Moreland City Council

# **SPECIAL COUNCIL AGENDA**

**DCF75/19      843-851 SYDNEY ROAD, BRUNSWICK - PLANNING  
PERMIT APPLICATION - MPS/2018/941 (D19/350800)**

*Figure 2 – Cross-section*

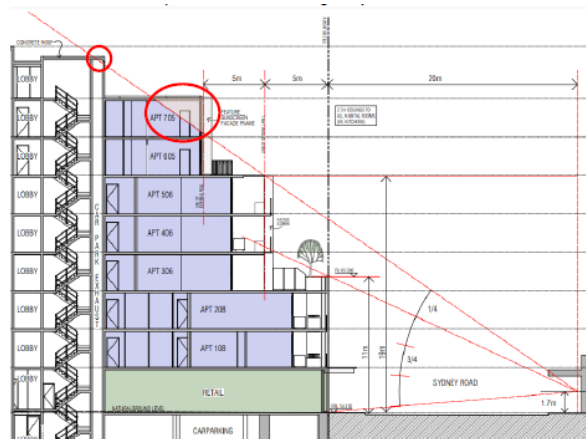
The DDO18 states that the upper levels should occupy no more than one quarter of the vertical angle defined by the whole building in the view from an eye-level of 1.7 metres on the opposite side of Sydney Road.

The proposal in its current form does not achieve this (as demonstrated in the circled area below).

The proposal also fails to adopt the same street setback for at least 75% of the height of the upper levels to avoid 'wedding cake' built form outcomes. Furthermore, while the materials at the upper level are distinct from the lower levels and are supported by Urban Design, the upper level does not present as 'visually recessive'.

- a) Deletion of level 7 (containing 6 dwellings), reducing the overall building height by a minimum of 3 metres.
  - b) The relocation of air conditioning away from habitable room windows.
